TECHNICAL BULLETIN

Special Instructions for Centric hose numbers:

TSB #150-1

Included flare nut.

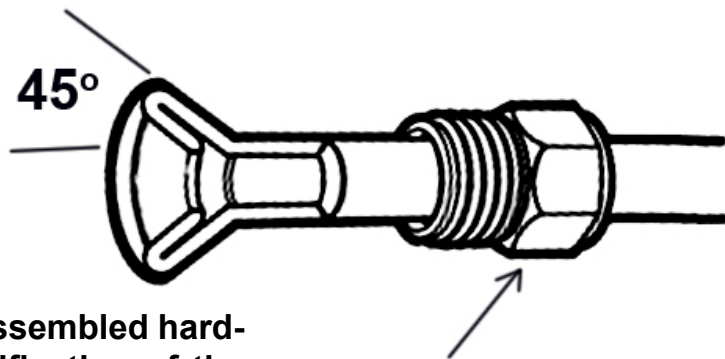
Original hose may be a one piece permanently assembled hard-line/flex hose. Replacement part requires modification of the original hard line section using the supplied flare nut. Installer must cut, deburr, install line nut, and flare end of hard line (double inverted flare), then attach replacement flex hose.

Proper fabrication of a high quality double inverted flare is the responsibility of the installer. It is recommended that the flare is performed with a flaring tool that uses smooth grips, rather than serrated grips, such as those sold by FedhillUSA or Mastercool®, for the best quality flare.
